# Product Safety Recall

## Various Seat Adapter Kits for Falcon BA-FGX and Commodore VE Seats

Sold by Huracan Fabrication between 15 March 2018 and 6 June 2019

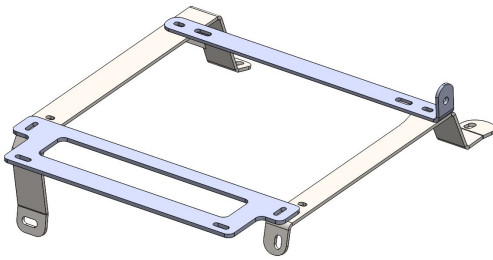
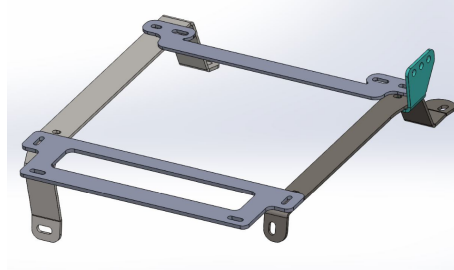
**Old kit - with defect**

**Defect:**

At loads exceeding 1.2 tonne seat belt strain, the seat belt mounting point may fail, resulting in the seat belt buckle breaking loose.

The product does not meet the required Australian Design Rule 'Vehicle Standard (ADR 3/03 - Seats and Seat Anchorages) 2006.'

If seat belt buckle breaks in the event of an accident, the seat occupant is at risk of serious injury or death.

**New kit - without defect**

Consumers should contact Huracan Fabrication to receive seat belt mount upgrade kit, free of charge.
